## **Accessibility Recommendations for the McBride Train Station**

Apex Access Consultants

# Village of McBride Historic Train Station

## **Proposed Village Side Entrance and Picnic Area**

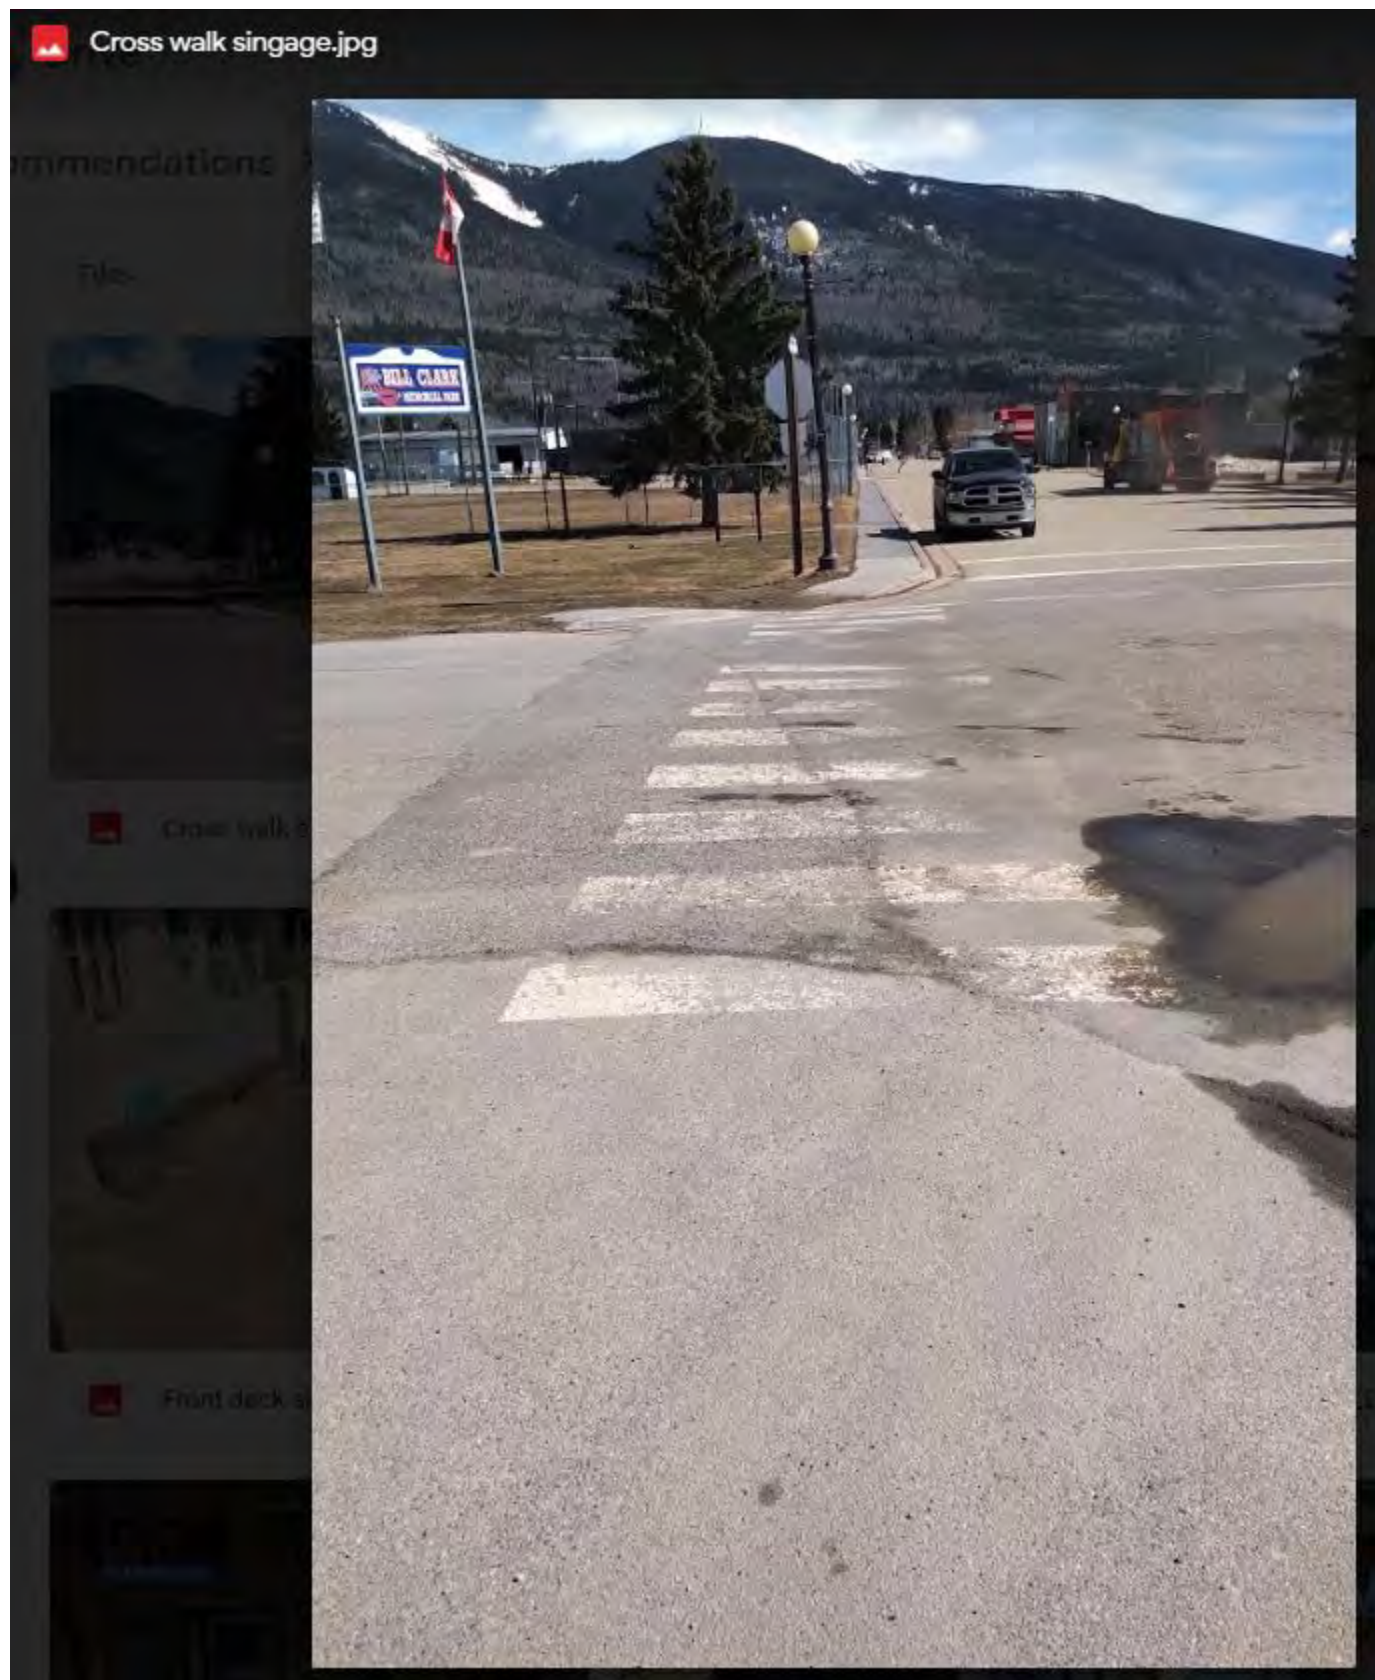
There is several recommendations for this proposal to be considered. There is ample seating provided. The consideration would be to provide different options such as seating with arms, or seating with backs. This provides options for individual needs. The next recommendation is to ensure there is ample space for the wheelchair access to the picnic tables. Designs with proper leg room and elevations are preferred. If there are fixed seats, ensure there is a proper space for access.

The final consideration from the proposal is a discussion on maybe having the centre ramp have access along the building to the restaurant entrance. To be able to use the same entrance as others maintains pride and dignity.

EXTERIOR PATHWAY – Track Side Seating

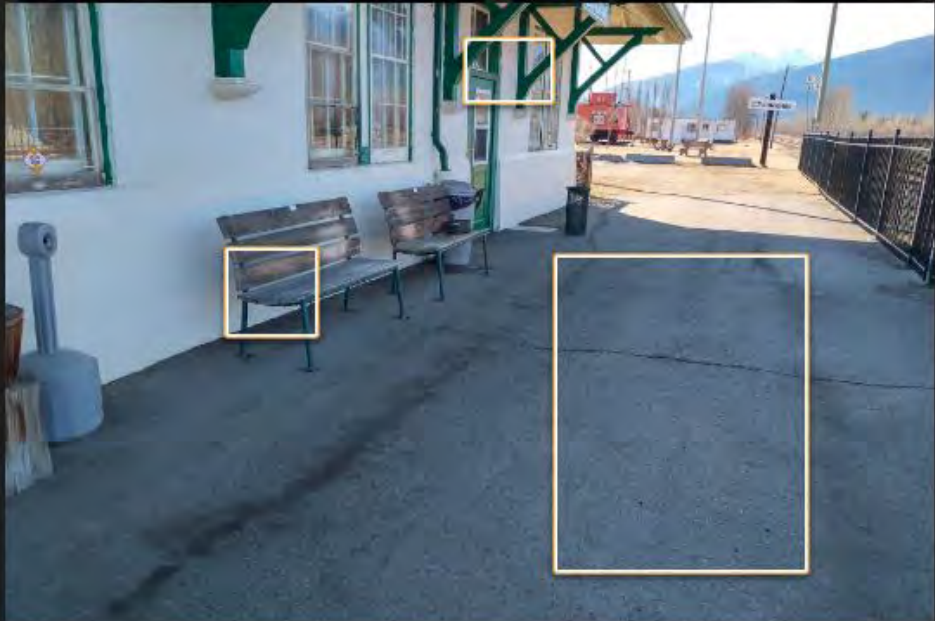
Ken Kuzminski  
10:47 23 Apr  
Blade signage would increase visibility

Ken Kuzminski  
10:46 23 Apr  
Benches lack the option of arm rests

Ken Kuzminski  
10:55 23 Apr  
Directional indicators can facilitate visitor flow and amenity locations

LOBBY INFORMATION – Lobby

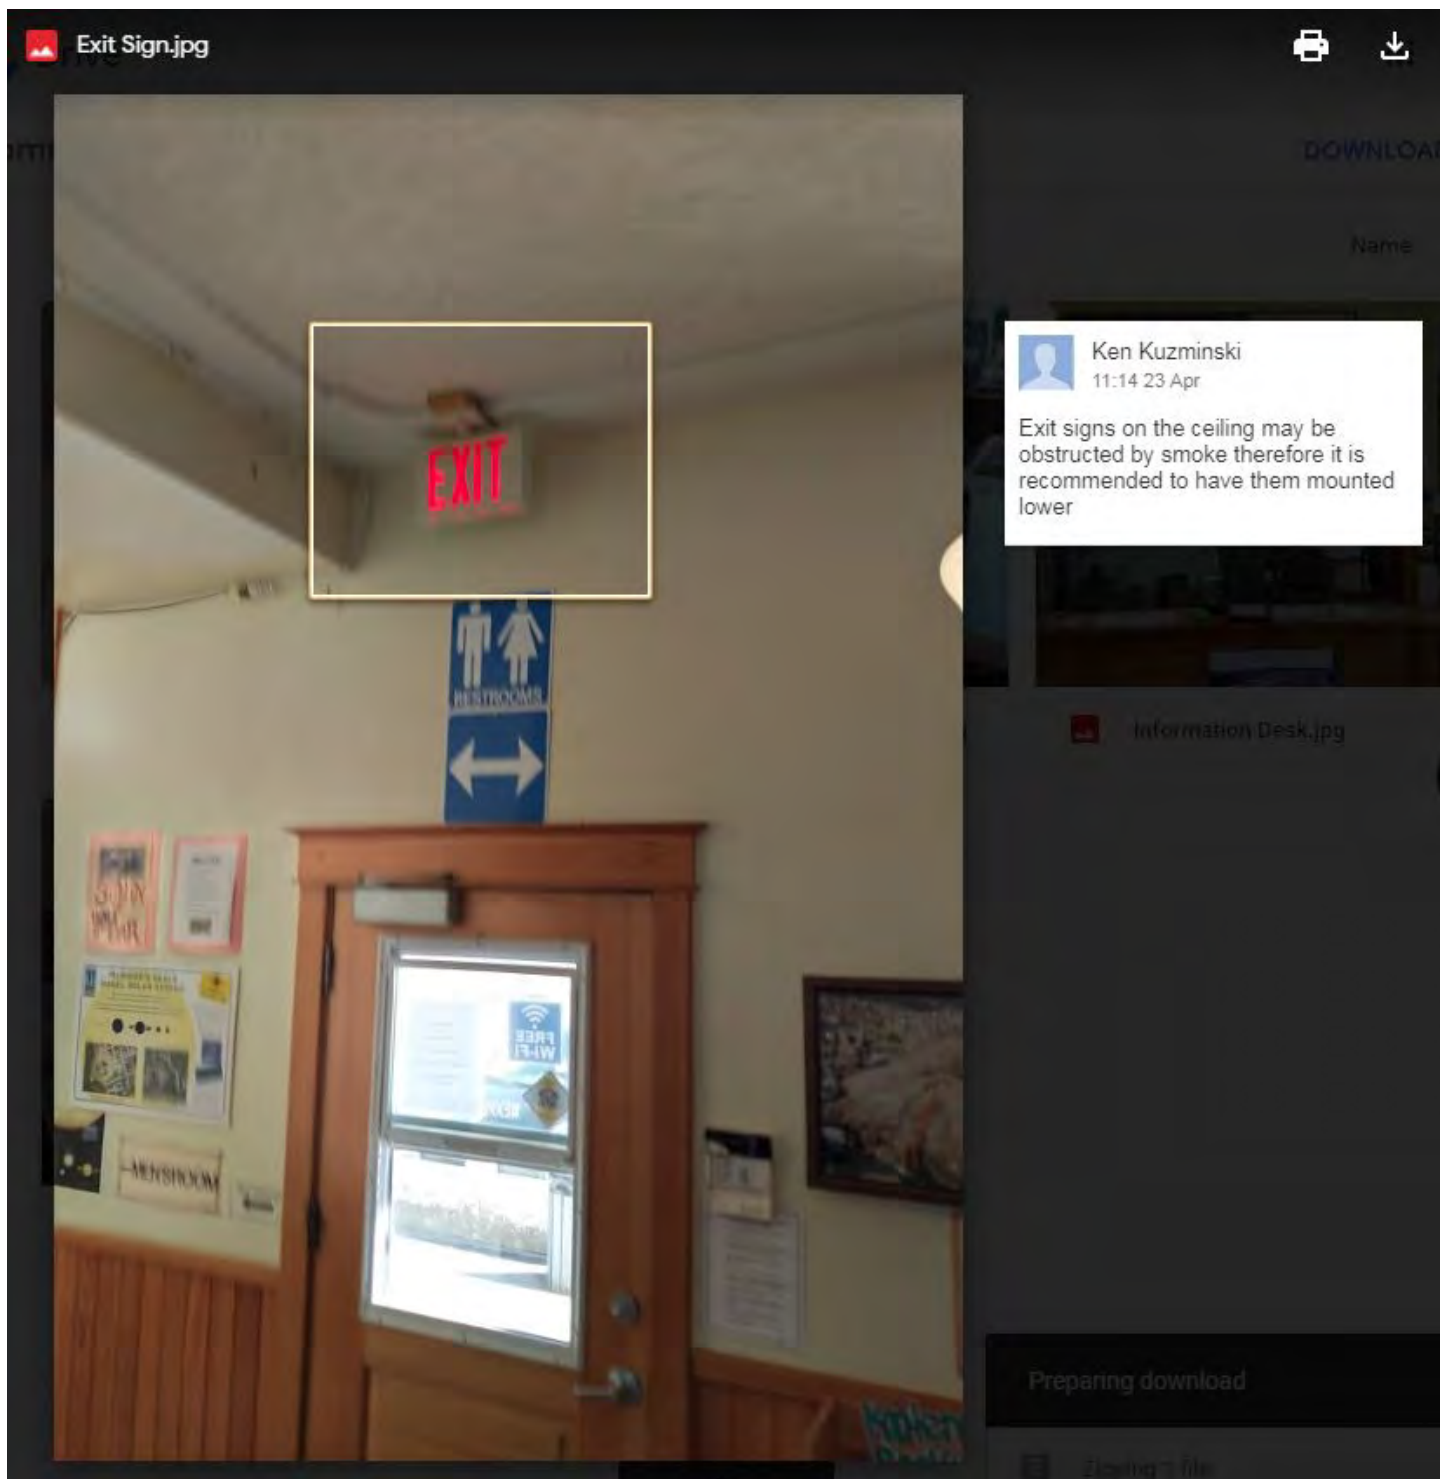
Ken Kuzminski  
11:17 23 Apr  
Blade signage would increase visibility

Ken Kuzminski  
11:17 23 Apr  
Blade signage would increase visibility

Ken Kuzminski  
11:15 23 Apr  
Blade signage would increase visibility

Ken Kuzminski  
11:15 23 Apr  
Blade signage would increase visibility

Ken Kuzminski  
11:16 23 Apr  
Seating options do not have the option of arm rests

## PARKING LOT

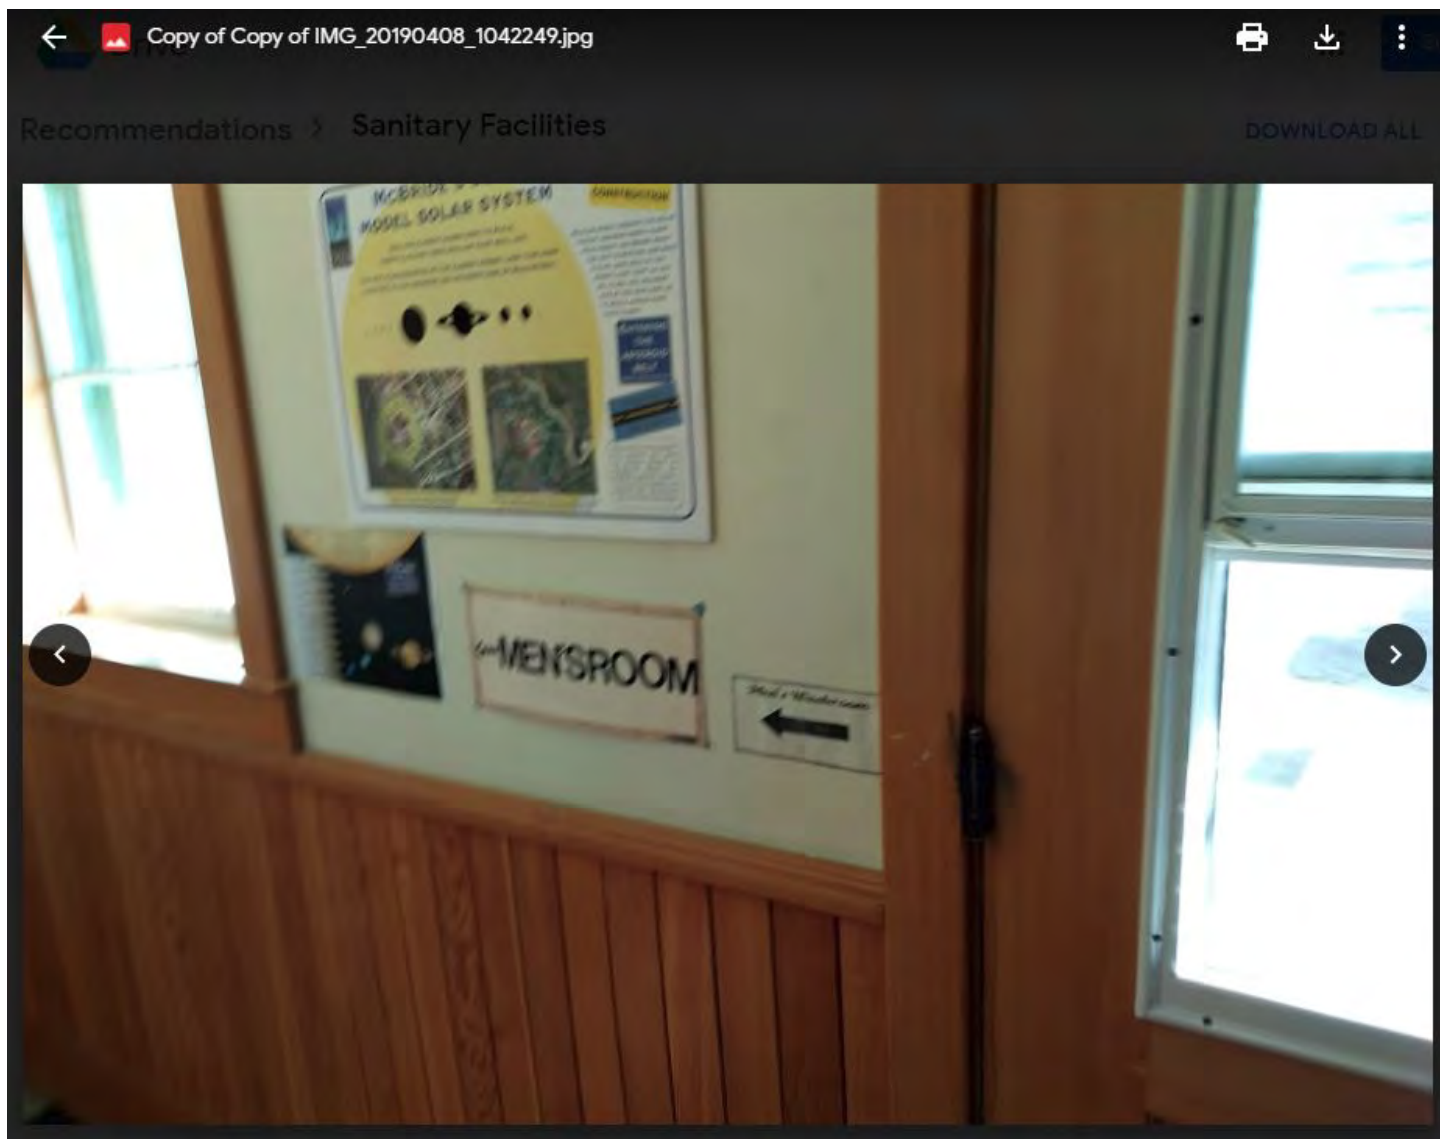
Main entrance is not immediately noticeable

Vertical signage would increase visibility of designated space

Concrete barriers could be painted to contrast surroundings

create a pathway through the vehicle access by extending crosswalk lines on asphalt

extend crosswalk indicators through the vehicle access and parking lot

WASHROOMS – Men's grab bars and dispenser

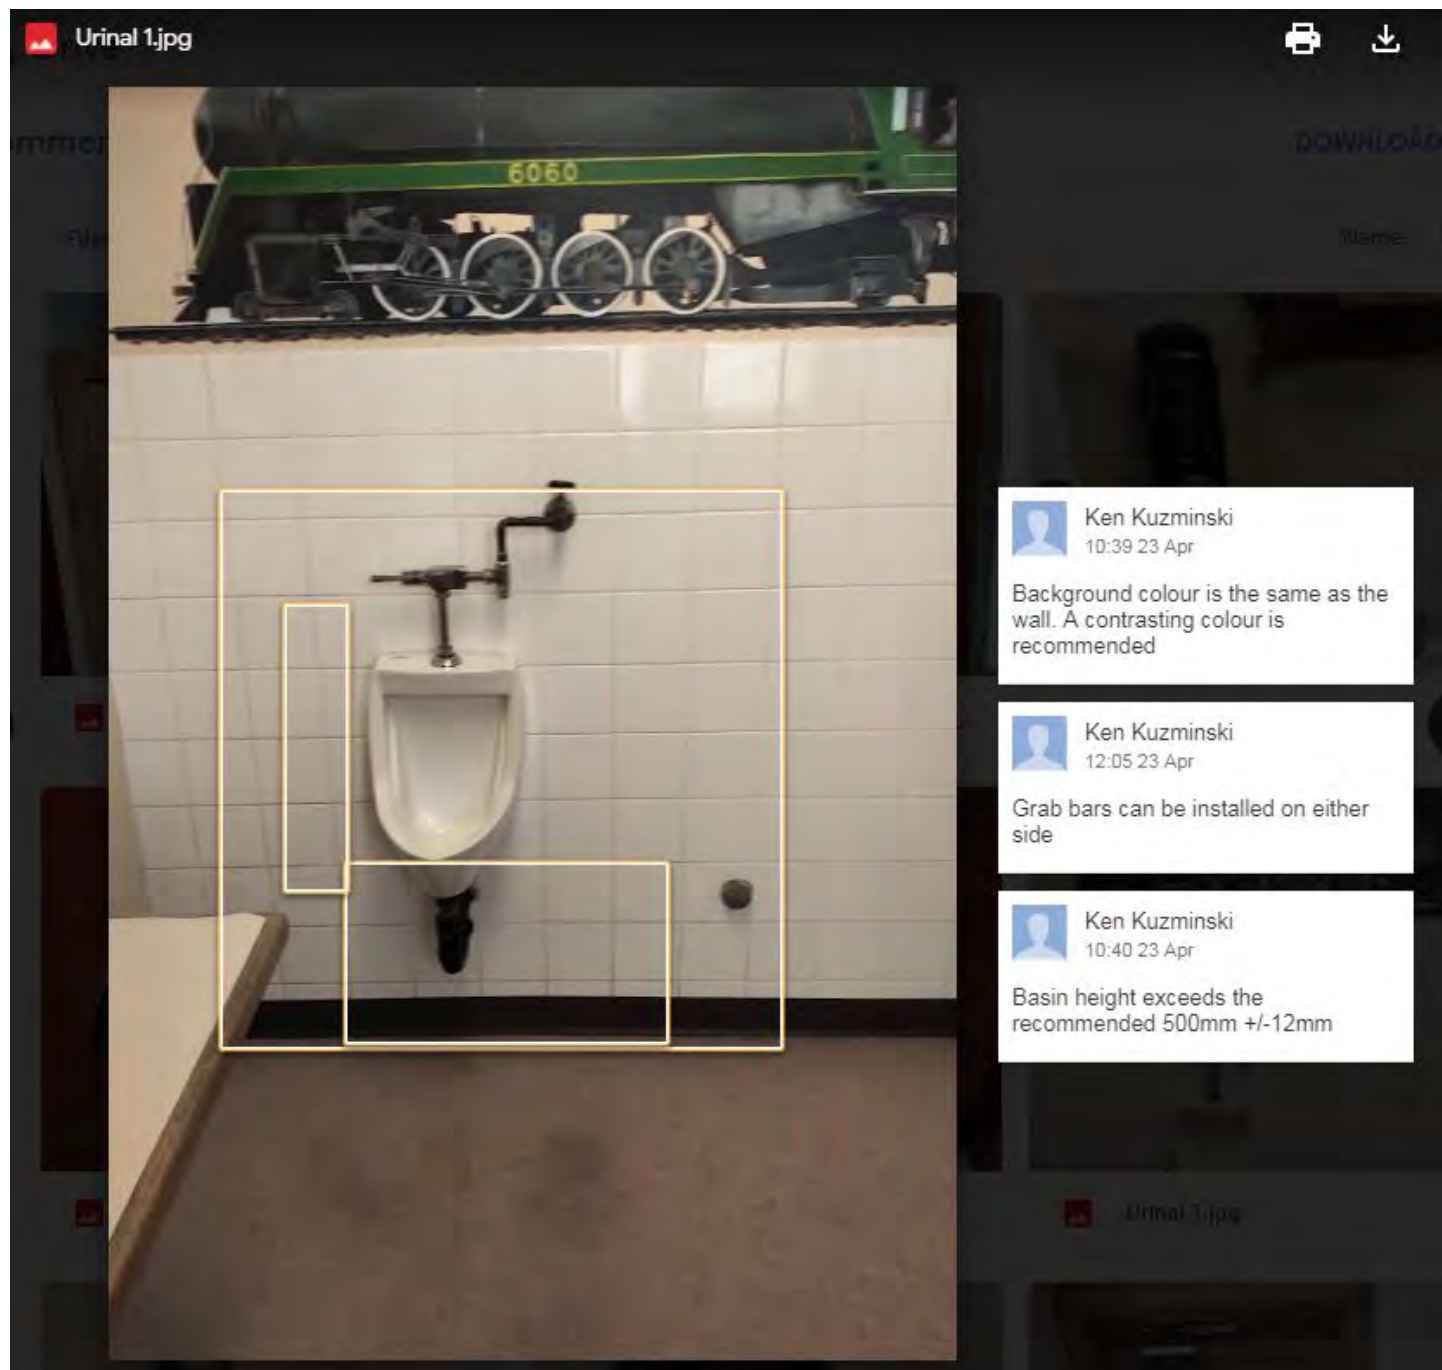
Grab bar shall be textured for grip. It shall be horizontal 300mm above the seat and run 600mm back from the front edge of the toilet and rise at a 60 degree angle from the front edge of the toilet. and be 600mm in length.

toilet paper dispenser is recommend to be installed as close to the front edge of the toilet and be below the height of the horizontal grab bar and allow access.
